CHAPTER 10 MEANS OF EGRESS

SECTION [B] 1005.3.2, EXCEPTION 1

IBC Interpretation No. 28-03

Attachment No. 1

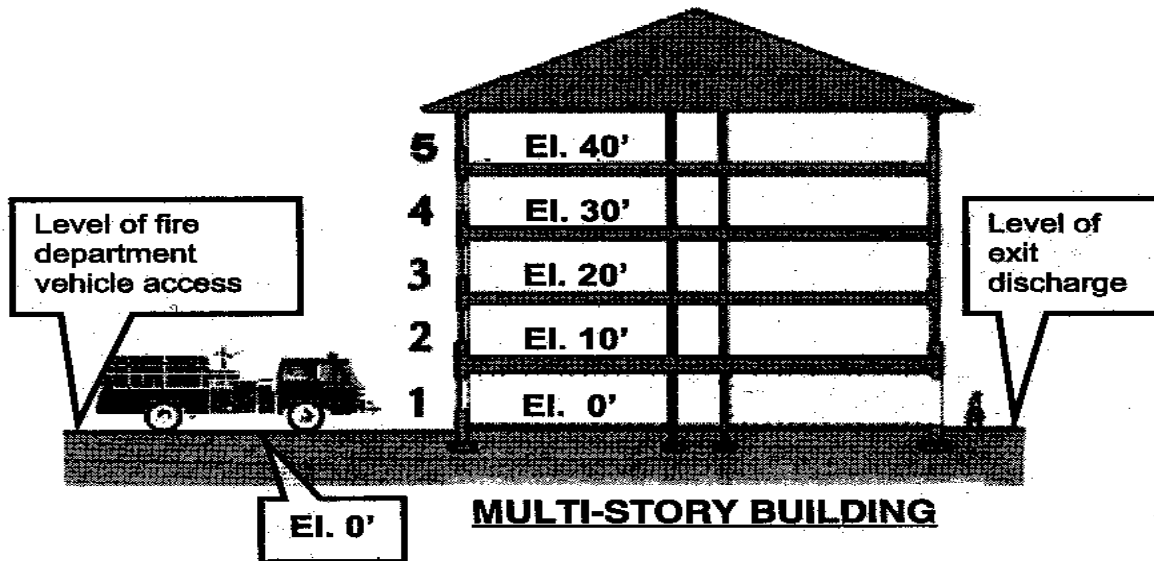
Q: Given a building on grade, without a basement, see Attachment No. 1 drawing of a Multi-Story Building. Is the second story of this building the first story above the lowest level of exit discharge?

A: No. When determining stories above the lowest level of exit discharge, a level, or floor level, is not a story. A "level" is the horizontal plane that is part of a story, not the entire story height. A "story" is the vertical space between the upper surface of one floor level and the upper surface of the floor level next above or below.

The level of exit discharge as shown in attached drawing of a Multi-Story Building is at elevation 0.0', the first floor level of the building is also at elevation 0.0' ; therefore, the level of exit discharge and the first floor level of the building are at the same elevation. The first story of the building begins at elevation 0.0' (first floor) and extends to elevation 10.0' (second floor). The first story of the building is the first story above the level of exit discharge.
